SUBJECT: Grand Gulf Nuclear Station
Unit 1
Docket No. 50-416
License No. NPF-29
Type C Testing of Test, Vent and
Drain Valves
Proposed Amendment to the Operating
License (PCOL-88/16)
AECM-88/0177

A. SUBJECT

1. PS 88-01: Deleting Type C Testing of Test, Vent and Drain Connections
2. Affected Technical Specifications:
 - Specification 3.6.1.2
Page 3/4 5-2, 3
 - TABLE 3.6.4-1
Pages 3/4 6-30, 38, 39, 40, 41 and 3/4 6-43, 44, 45

SCHEMATIC OF M61 ISOLATION VALVES ⁽¹⁾

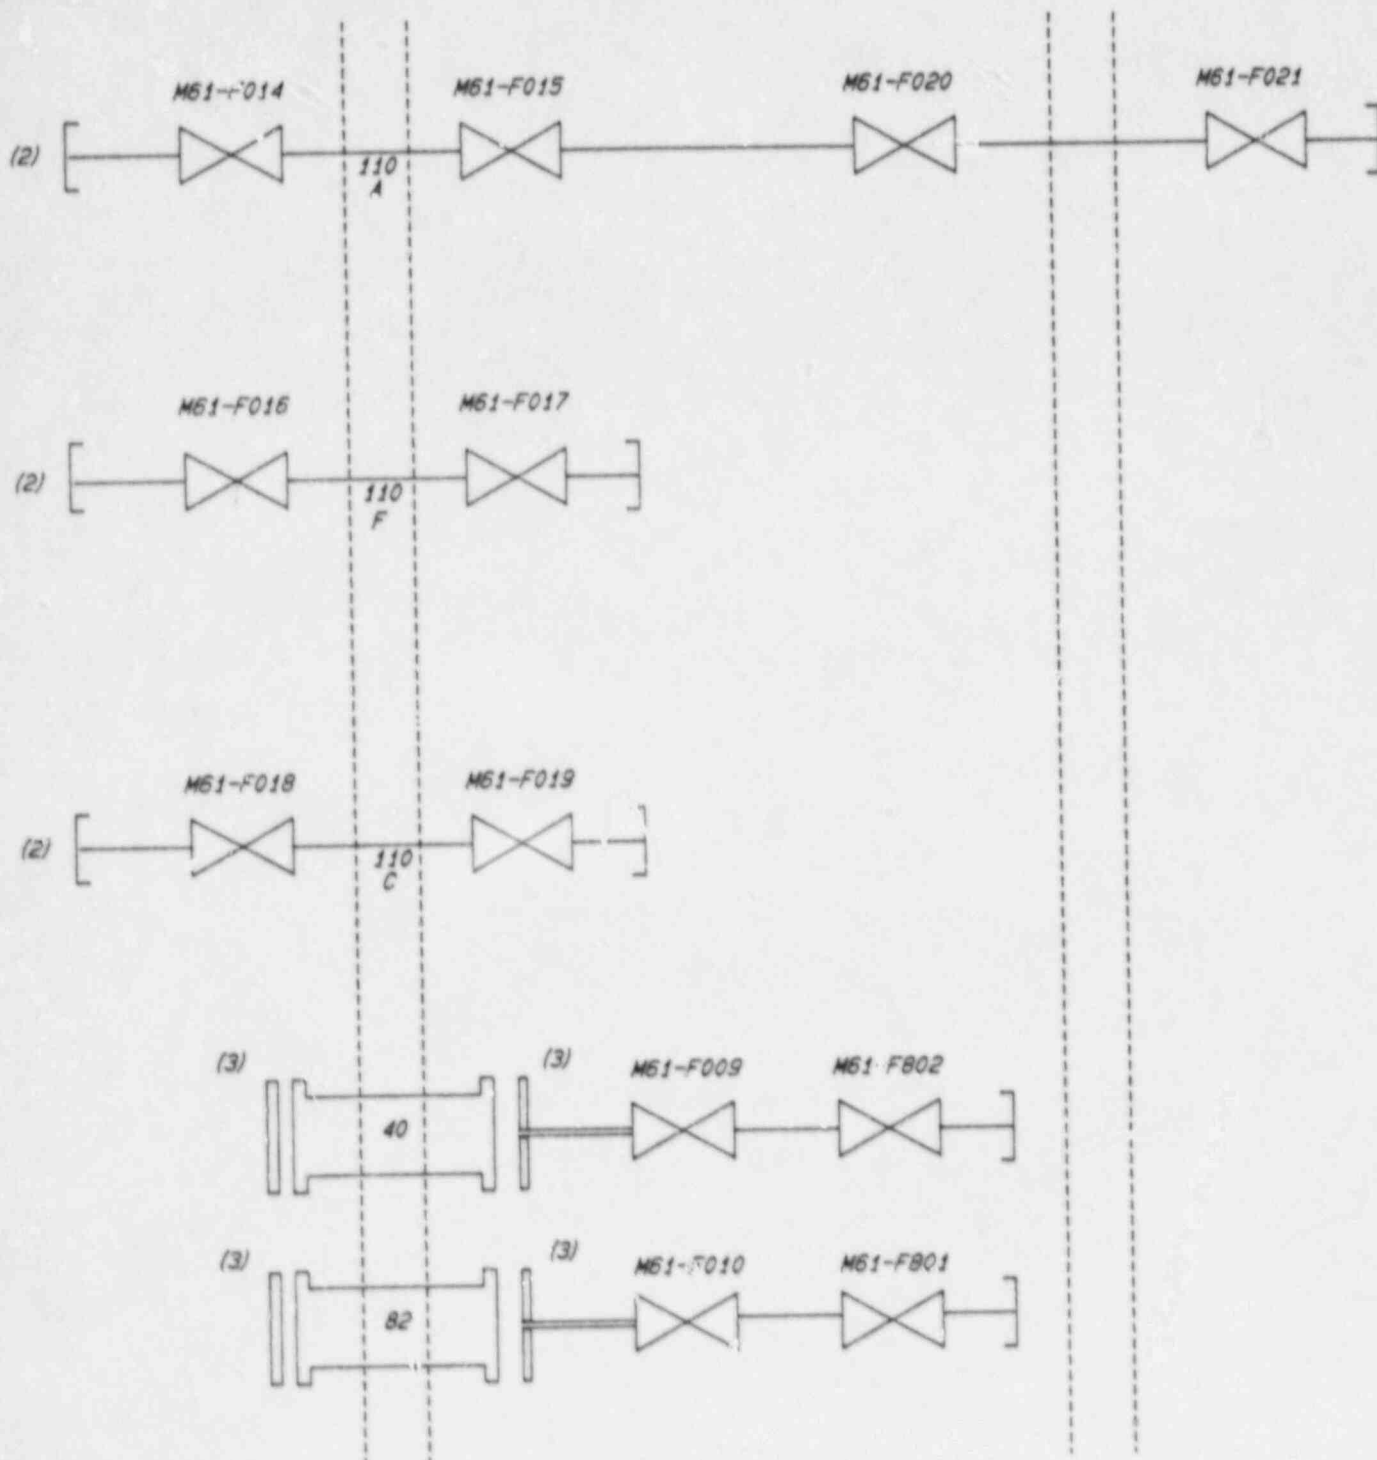
6. Eight valves (identified by system identifier M61) cannot be pressurized by any of the programs identified in C.4 above because they are in penetrations that are opened only for the Type A Test (ILRT) required by Technical Specification 4.6.1.2.a and the Drywell Bypass Test required by Technical Specification 4.6.2.2. The penetrations do not connect to any other system piping and are closed both inside and outside the containment pressure boundary by flanges with flexitallic gaskets and/or globe valves and pipe caps during power operation. The flanges will continue to be Type B tested as required by Appendix J and Technical Specification 4.6.1.1.a. The acceptance criteria used at GGNS for these flanges is zero leakage. Further testing of the associated TVDs is not necessary because each penetration is sealed by at least four separate and independent pressure boundaries. In the unlikely event that all four (or more) independent pressure boundaries leaked during an accident pressurizing the containment, the pressure differential would push the inboard pipe cap tighter onto the pipe end tending to minimize the leakage. See enclosed diagram of these penetrations and barriers.

Eight valves are in penetrations that do not connect to any other system piping and are closed both inside and outside the containment pressure boundary by flanges with flexitallic gaskets and/or globe valves and pipe caps during power operation. The flanges will continue to be Type B tested as required by Appendix J and Technical Specification 4.3.1.1.2. The acceptance criteria used at GGNS for these flanges is zero leakage. Further testing of the associated TVDs is not necessary because each penetration is sealed by at least four separate and independent pressure boundaries.
